## **EFFINGHAM COUNTY** SKETCH PLAN SUMITTAL FORM

I am pleased to provide you with a review of the Sketch Plan submitted for Savannah Marine Terminal – Transloading Facility, which can be found below.

### Sketch Plan Review

Submittal Documents Sketch Plan Aug. 2022

# 1054 OLD RIVER ROAD

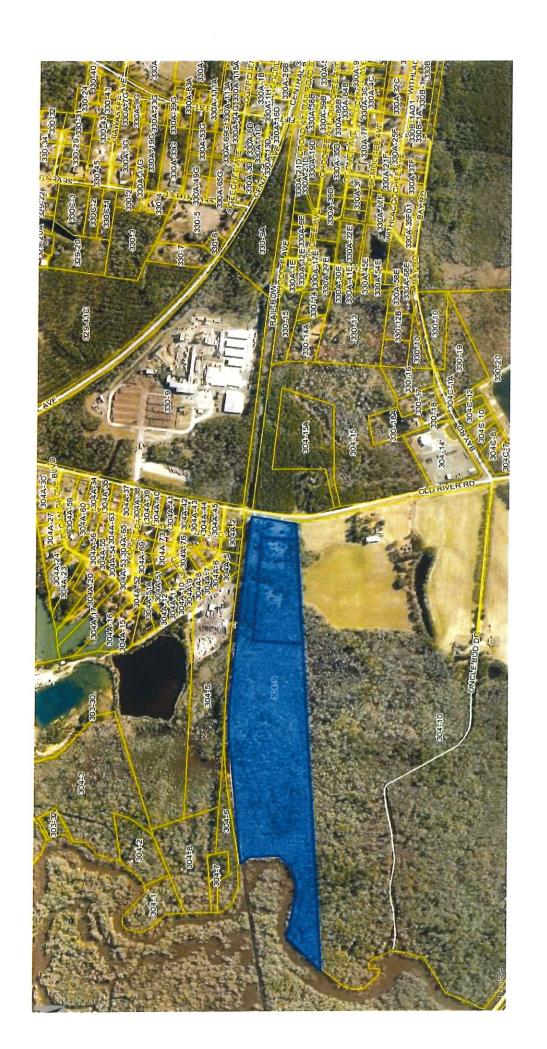
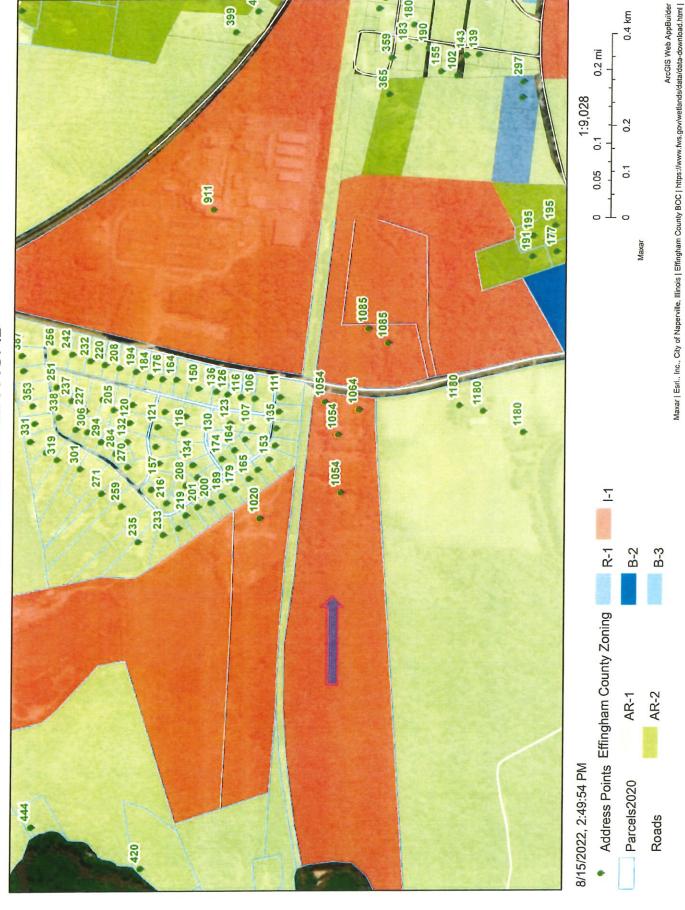
- 1. For industrial zoned property, the street buffer shall equal the required zoning buffer necessary for the property across the street. In this case it would be 25-ft.

- 2. Please show the right of way for Old River Road on the sketch plan. Furthermore, show any driveway access points.
- 3. The Sketch Plan Checklist, submitted with the application, has all of the items checked as 'Y' for yes, however, upon review all those items are not included in the submitted sketch plan. Please review the checklist and add any missing items to the proposed sketch plan.

- 4. The original proposed use for the site, as described in the zoning variance application, was to be a grain and timber distribution. However, the underground grain hopper is no longer included and the timber storage was reduced by about ½. Is this still the same proposed land use, or have there been modifications.

- 5. Please include the location for the underground grain hopper on the plan. This item was included on the proposed concept plan.
- 6. Please include the location of the scale for containers/trucks on the plan. This item was included on the proposed concept plan.

- 7. Please provide a parking calculation for the proposed site.
  - a. It shall be noted that the parking spaces for passenger vehicles was reduced by ½ since the previously submitted concept plan.

- 8. There shall be adequate access to the office building from the passenger vehicle parking area, especially the handicap parking space.
- 9. Please identify the loading spaces on the plans. Section 3.30.6 of the county ordinance provides the schedule for number of spaces per area of storage. Keep in mind the minimum space for truck loading shall be: 30-ft in length, 12-ft in width.

- a. Keep in mind that there needs to be enough space to maneuver the design vehicle through site to and from the applicable loading spaces.
  - b. It shall be noted that there was a large area for truck parking and misc. storage on the concept plan that is not included in the proposed sketch plan.

- 10. Please identify the location of the proposed outlet for the site's stormwater management system on the plans. The full analysis of the stormwater management system is not required at this stage in the process, but the major features/structures should be included. The plan for the routing of stormwater should be clear.

- 11. Is any type of solid waste disposal area going to be proposed? If so, include depict this on the plan. Keep in mind that the applicable truck used to access any dumpster needs to be able to maneuver through the site.

- 12. The roadside drainage shall not be impeded by the proposed driveway construction. Ensure that a culvert is included in the design.
- 13. It is understood that an extent of this site is being proposed with some form of gravel/aggregate material, however at a minimum, the county right of way needs to utilize proper paving.

- 14. Is there any plan in place for the water distribution/wastewater serving the site?
- 15. Please provide some form of delineation for the wetlands on site. It is annotated that there are wetlands, but there is no line defining those limits.

- 16. It shall be noted that the railroad owner will need to issue an approval of the proposed rail plans prior to final approval of final site development plans.
